DEVELOPMENT
CONSULTANTS, INC.

SUBJECT: 25-040 Loaf Land Subdivision - Comment Response

“LOAF LAND SUBDIVISION” AT MOUNTAIN ROAD, COPLIN PLANTATION, MAINE

S2.1

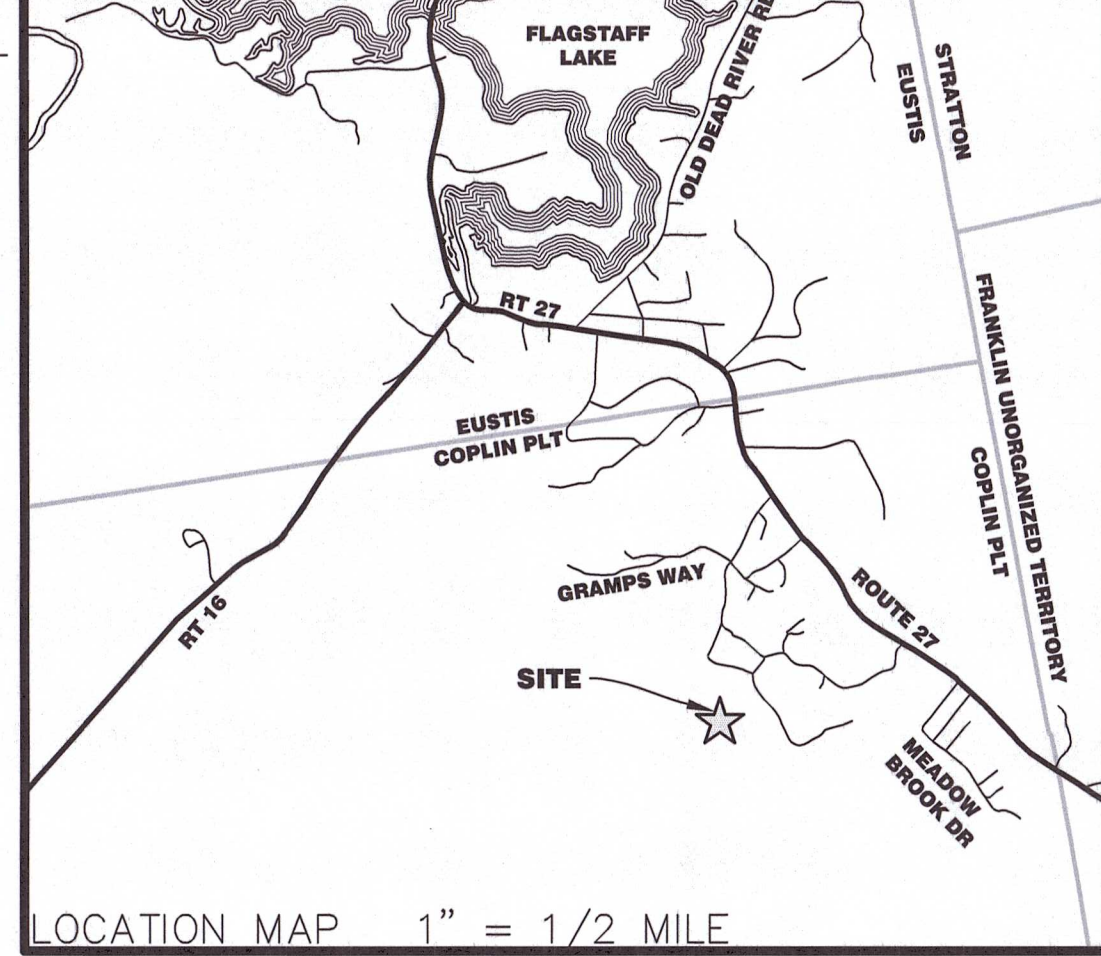
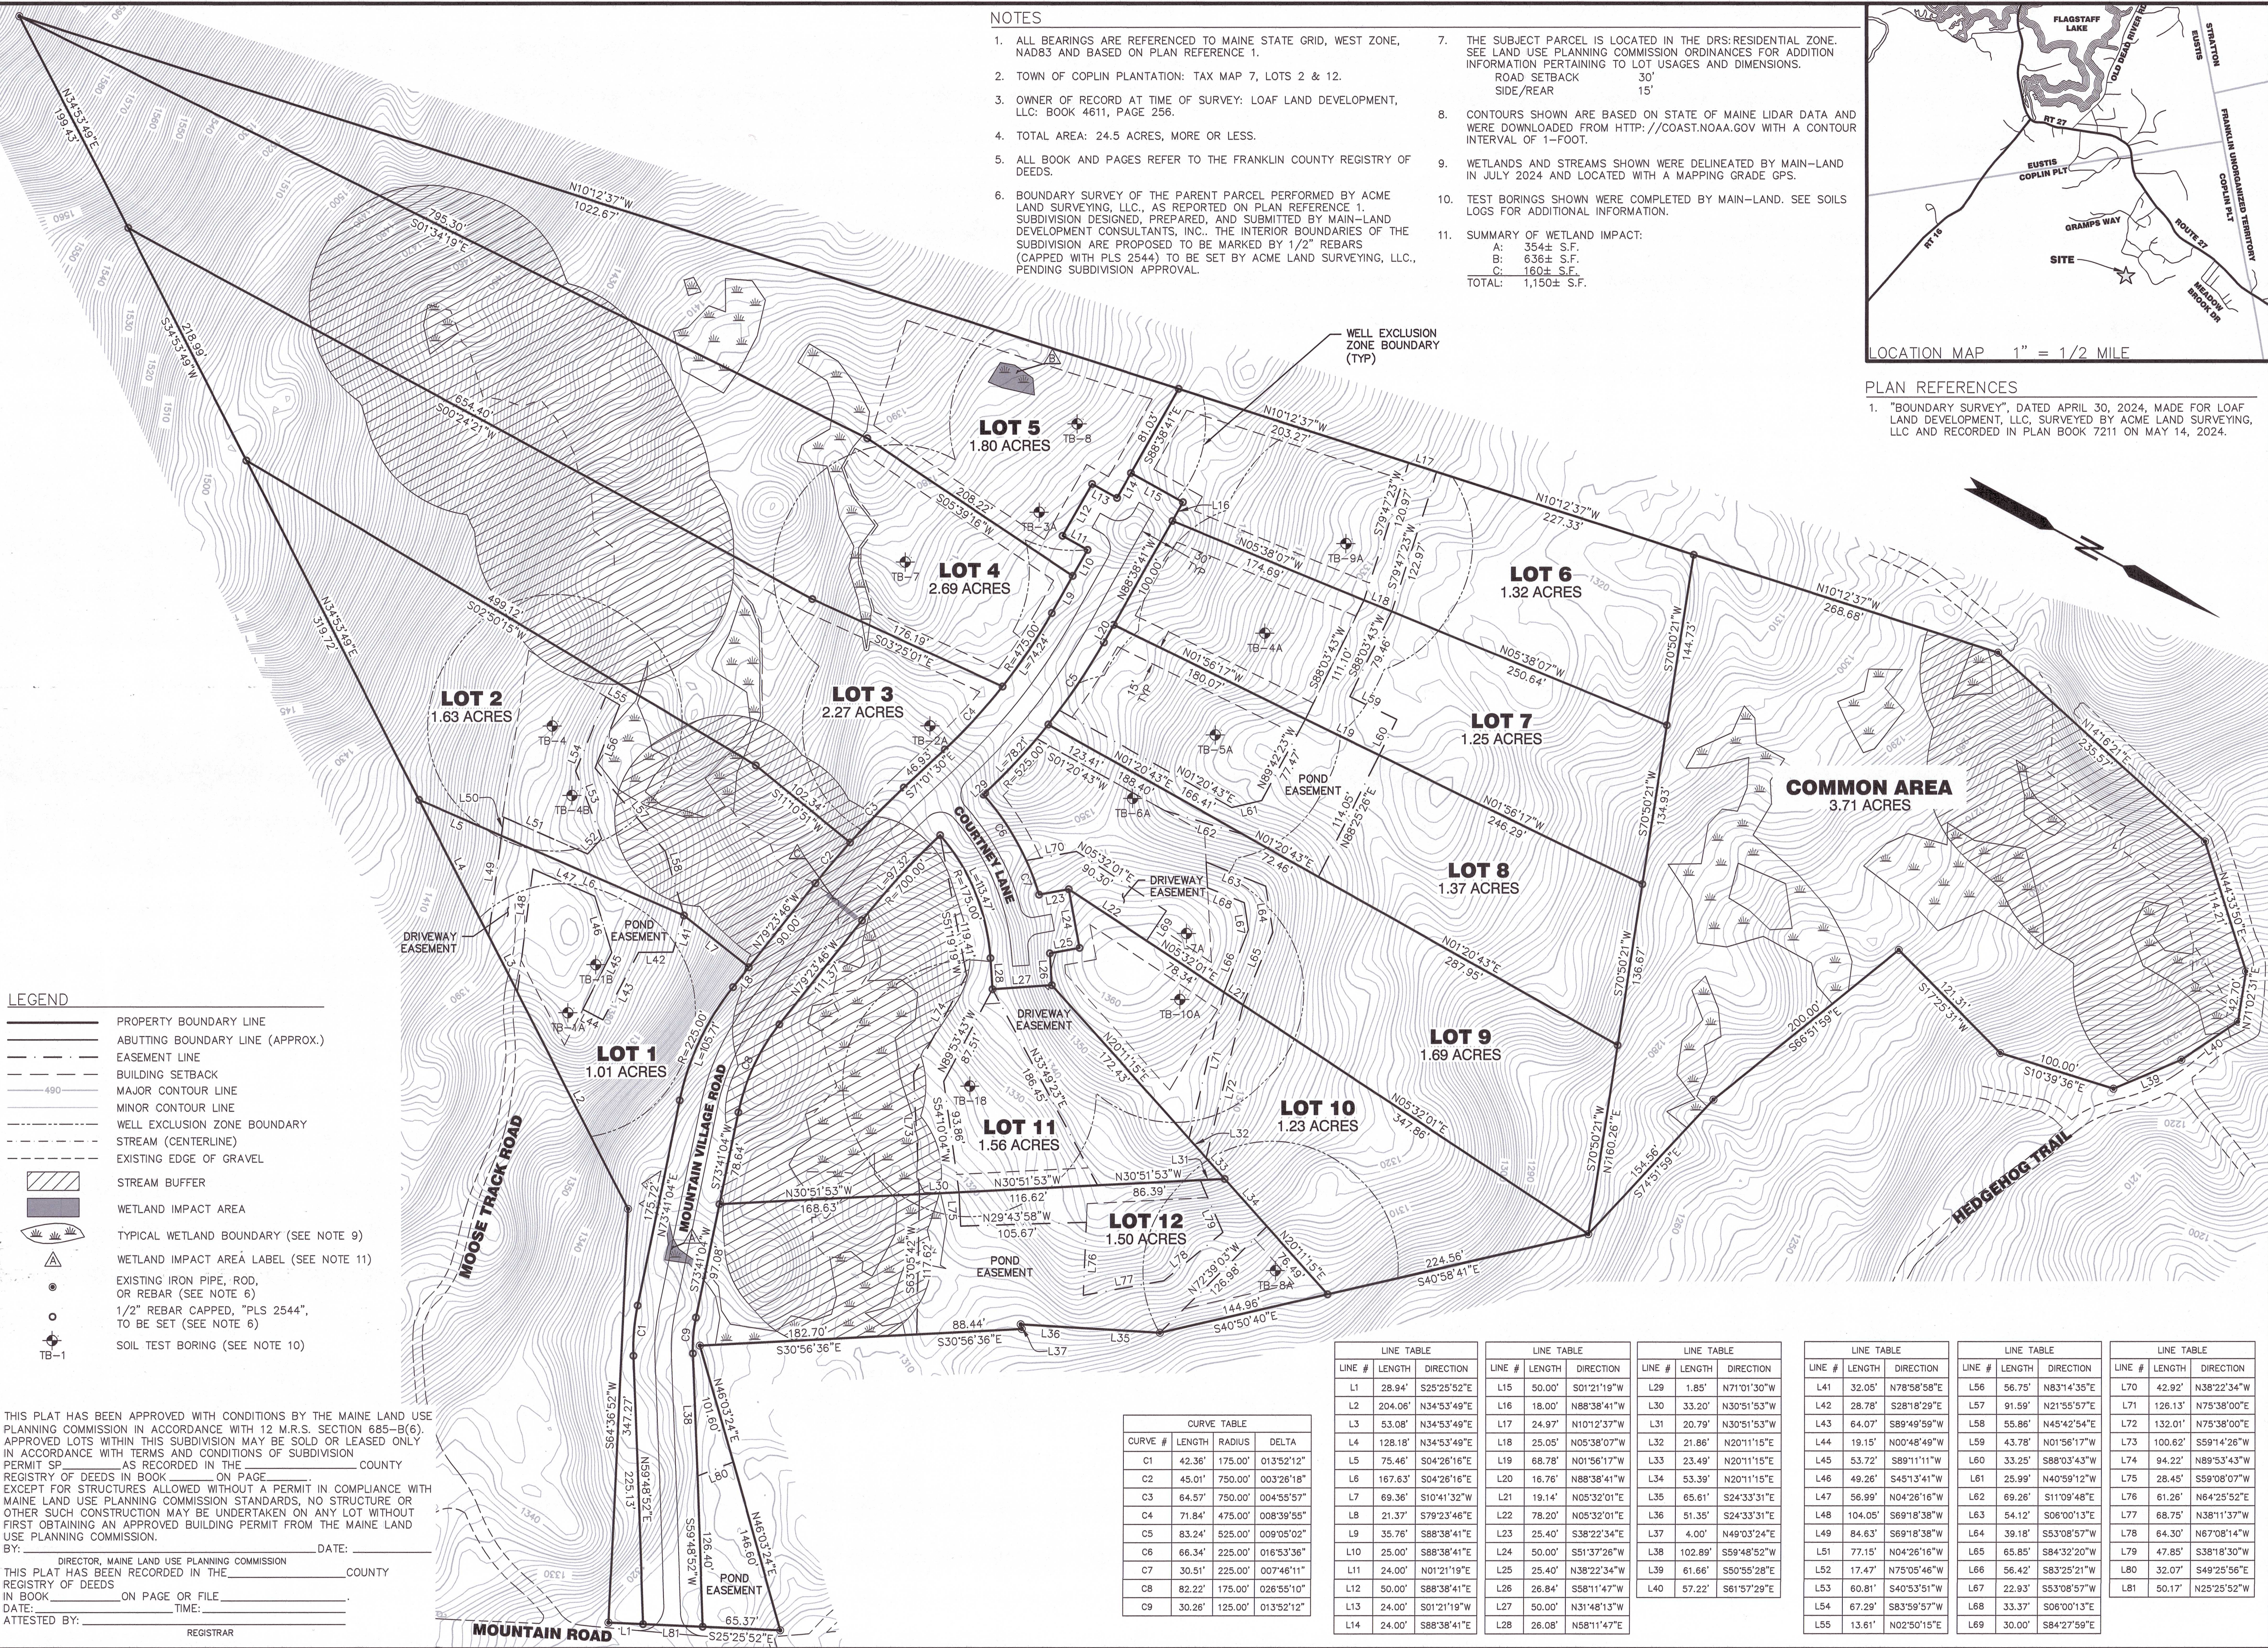
- *Wetland Alteration Supplement (Ex. 35)*
 - *Clarify the amount of wetland impact proposed. The Subdivision Plan (Ex. 10, S2.1) shows 354 sq ft (Note 11), the Grading Plan (Ex. 10, C3.1) shows 374 sq ft, and the Wetland Alterations Supplement (S-3) shows 514 sq ft proposed (Q. 7).*

S2.1 Subdivision Plan has been amended to include a septic test boring within the building envelope.

There is 990 sf of Forested Wetland impact and 160 sf of Stream impact, resulting in a total of 1,150 sf. All plan denotations have been updated to match the updated Form S-3.
